To: Chase Ridge  
Planner I, City of Dublin

From: Dan Phillabaum, AICP, RLA  
Landplan Studios, LLC

Date: September 17, 2019

**Re: 156 South High Street (19-056ARB)—Architectural Analysis of Façade Details**

Dormer Width, Spacing and 1<sup>st</sup> Floor Rough Opening Widths

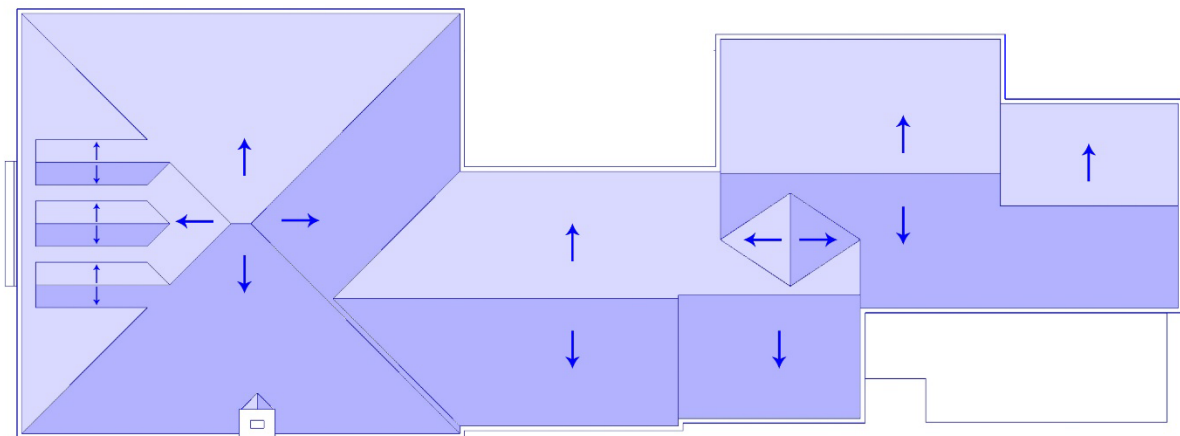
- The width of the proposed rough window openings on the Front (West) Elevation is 3 feet. This appears to be wider than the typical rough opening dimension for windows in the surrounding area.
- As noted previously, clarification of the proposed window height for these windows is needed. If 6 over 6 windows are proposed, the sill height is  $\pm 1.5$  feet above the first floor elevation. Typical sill heights for ground story windows range between 2 to 2.5 feet.

- No sills are visible as part of the proposed window trim. Projecting sills should be provided between the casing and apron.
- The window casing width varies between the front elevation and all other elevations.
- No mullions are present between the ganged windows on the Front (West) Elevation.

Roof Plan  
(Interpolated from Elevations provided by applicant)

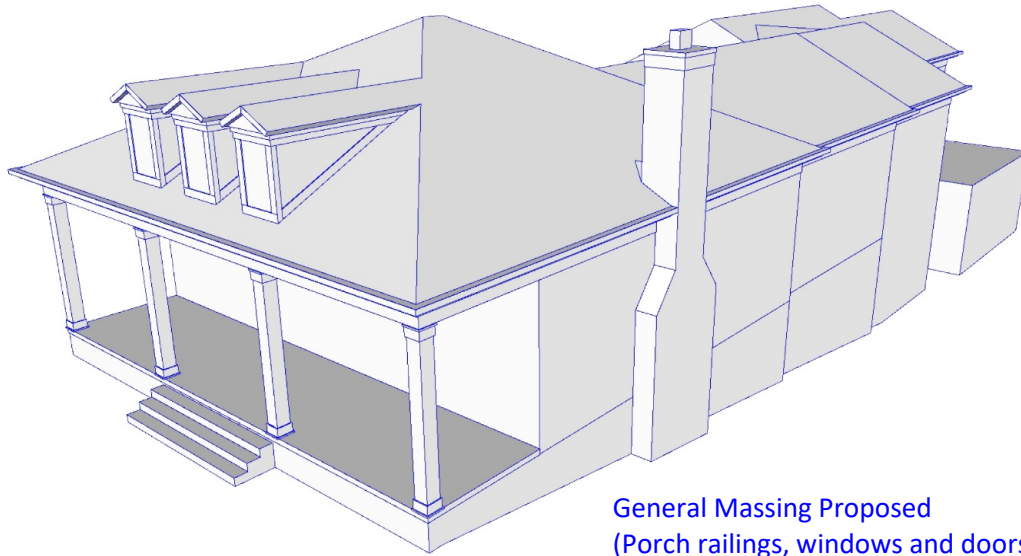
- As proposed, the three dormers cover a significant portion of the west facing roof plane. It is recommended that the space between dormers be wider than the dormers themselves. There is  $\pm 2.5$  feet between the 3-foot wide dormers. As a non-functional ornamental feature, the arrangement of the dormers should be reevaluated.

- The outermost dormers have been pushed as far apart as possible on the principal roof plane, resulting in the roof plane of the outer dormers as an extension of the principal roof plane. This is an uncommon arrangement for dormers of this size.
